28 May 2025  
Ref: 252145.2L

Submission on behalf of the Owners' Corporations of 'Metro Residences' – 'Metro View' (SP 88677) at 69 Albert St, 'Metro Spire' (SP 88678) at 1 Post Office Lane and 'Metro Grand' (SP 88679) at 438 Victoria Avenue, Chatswood – SSD-63324208 410-416 Victoria Avenue, Chatswood – Construction of a build to rent (BTR) development with ground and first floor retail premises, 260 BTR units, communal facilities and 3 levels of basement

**Figure 2: Extracts from SSD Shadow Diagrams**  
(Source: SSD plans; annotated by DC)

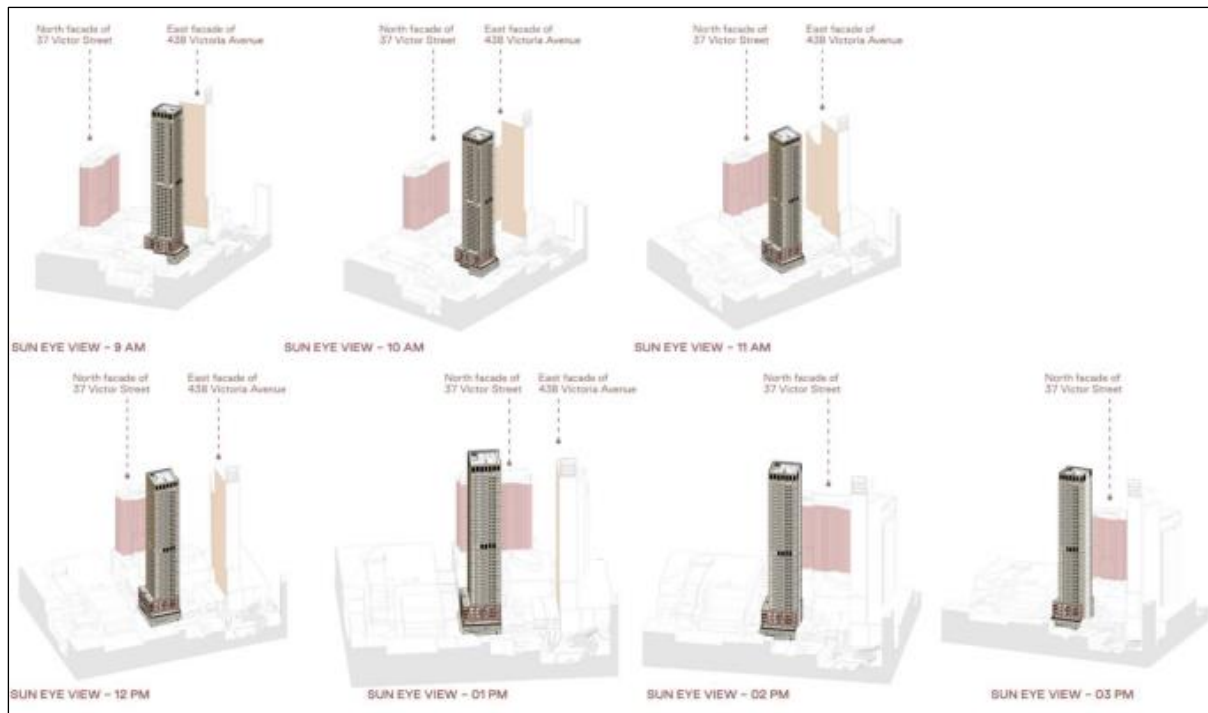
The proposal will result in additional overshadowing of Metro Spire and Metro View as shown in the midwinter shadow diagrams and 'Sun Eye View' diagrams from the EIS (p. 93)/architectural plans (see **Figures 2** and **3**).

The proposed SSD will have a significant adverse impact on the level of solar access achieved to the south-east-facing units in Metro View. The level of impact is such that these units will not achieve 2 hours solar access in accordance with the criteria under the ADG.

As shown above, at 9am and 10am, the proposal will overshadow most of the eastern façade of Metro View. At 9am, solar access is retained only to the SE corner of the building. At 10am, solar access is retained to the northern elevation/NE corner. This level of impact represents a significant and marked reduction in solar access to these units compared with the existing situation.

At 11am, the diagrams show there is no direct impact on Metro View and solar access is achieved to the eastern façade.

However, at 12 noon, due to the angle of the façade, the diagrams show that solar access would not be achieved to the south-east-facing units in Metro View.

Accordingly, the proposal will reduce the solar access of south-east-facing units in View such that they would not achieve the required 2 hours at mid-winter to living rooms/private open space. The 'as built' plans of Metro View indicate that there are units with living rooms and private open space at Levels 5-31 which would be adversely affected by this loss (see **Figure 4**). This will result in a significant loss of amenity to these units which currently achieve 2+ hours solar access throughout the morning.

As shown in the diagrams above, at 9am, the proposal will overshadow the SE corner of Metro Spire. By 10am, Metro Spire is not overshadowed. This overshadowing would affect the SE corner living rooms/wintergardens of units at each level of the building but is considered minor.

It is submitted that the proposed development should be amended through provision of greater setbacks to the proposed tower to reduce its bulk so that the south-east-facing units in View achieve the minimum 2 hours solar access to living rooms/private open space. In addition, the assessment of compliance and impact should be revised and based on the actual unit layout within each of the buildings rather than on the basis of 'facades'. Without such an assessment the conclusions reached in the submitted SSD documentation cannot be relied upon.

**Figure 5: EIS View Impact Diagram**

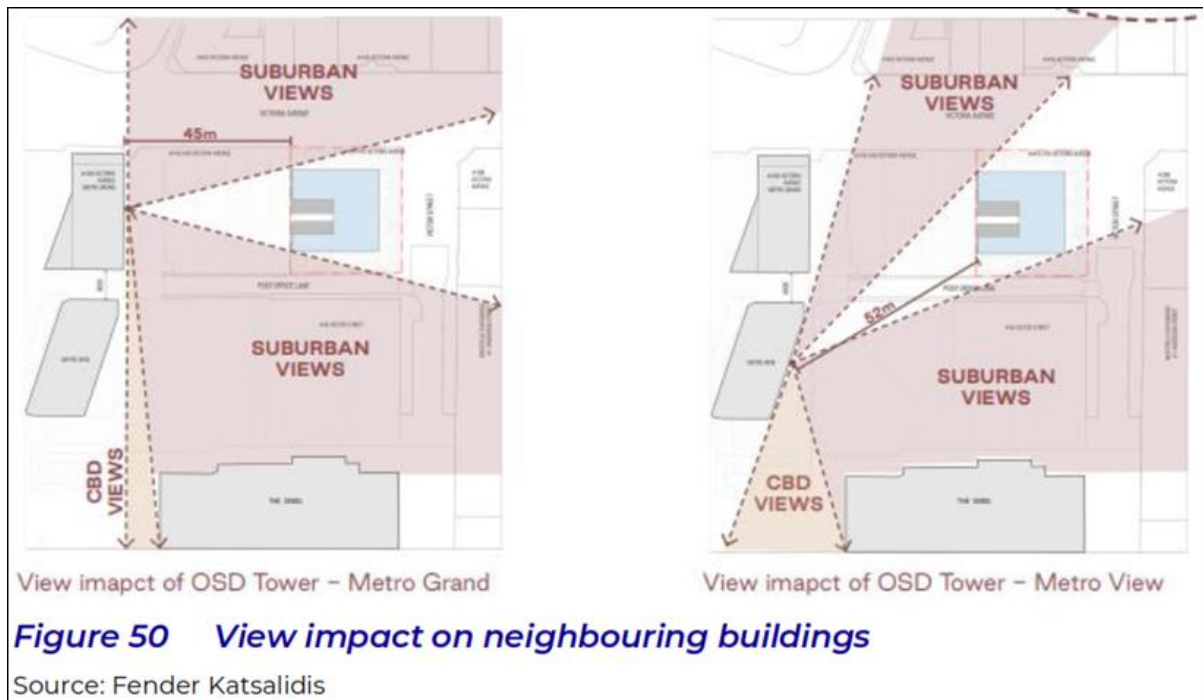
The proposal will result in a loss of views from both Metro Spire and Metro View. The EIS contains diagrams showing "View Impact" (noting the heading "Metro Grand" below should be "Metro Spire") (see **Figure 5**).

The EIS acknowledges that the Metro Spire and Metro View have “expansive suburban” views which will be impacted by the proposed SSD, however, concludes that the impact is “acceptable” on the basis of the portion of view affected and the dense CBD context (p. 98). The EIS also indicates that the views affected are not ‘iconic’ or ‘highly valuable’ in the context of *Tenacity*.

The assessment of views in the SSD documentation is refuted on a similar basis to that undertaken in relation to overshadowing and loss of solar access noted above, in that the assessment is highly generalised and makes no attempt to assess the impact on particular units, taking into account varying layouts and outlooks. This is illustrated by the diagrams in **Figure 5** above, which depict the view from a single point in the centre of each building façade.

In particular, it is noted that very few units have the full width of view described/illustrated in the EIS and SSD documentation. Arguably only the units at the two top floors of Metro Spire have that view as they occupy the whole level. At the lower levels of Metro Spire and Metro View, the easterly/north-easterly views vary according to unit layout. In this regard, the units most affected by the proposal will be the single aspect easterly facing units in Metro Spire at the lower levels – Levels 11-20 – which directly face the SSD site.

Apart from the units at the lowest levels of Metro Spire (Levels 5-10) which have opaque glass to the eastern façade, all east-facing units in Metro Spire will be affected by a loss of views/outlook to the east resulting in a loss of amenity to numerous dwellings. From Metro View, the units in the north-eastern part of the building at all levels will be most affected.

In addition, the view impact assessment in the EIS underplays or discounts the value of the existing views to the amenity of the units within Metro Spire and Metro View. This value is partially derived from their expansive, uninterrupted nature, albeit that they are over a suburban context without ‘iconic elements’. As a result, the assessment underplays the impact of the proposed SSD on the existing views and the amenity of the units in our clients’ buildings. Based on the diagrams above, the impact of the proposed development would be to remove the central portion of the existing wide view, which is considered to be a significant impact as it would fundamentally change the nature of the existing view from the affected units and reduce their amenity.

It is submitted that more detailed assessment of this issue is required which properly takes into account the unit layout of our clients' buildings rather than the generalised approach taken in the EIS and SSD documentation. This will enable a proper assessment of the view impact of the proposed SSD.
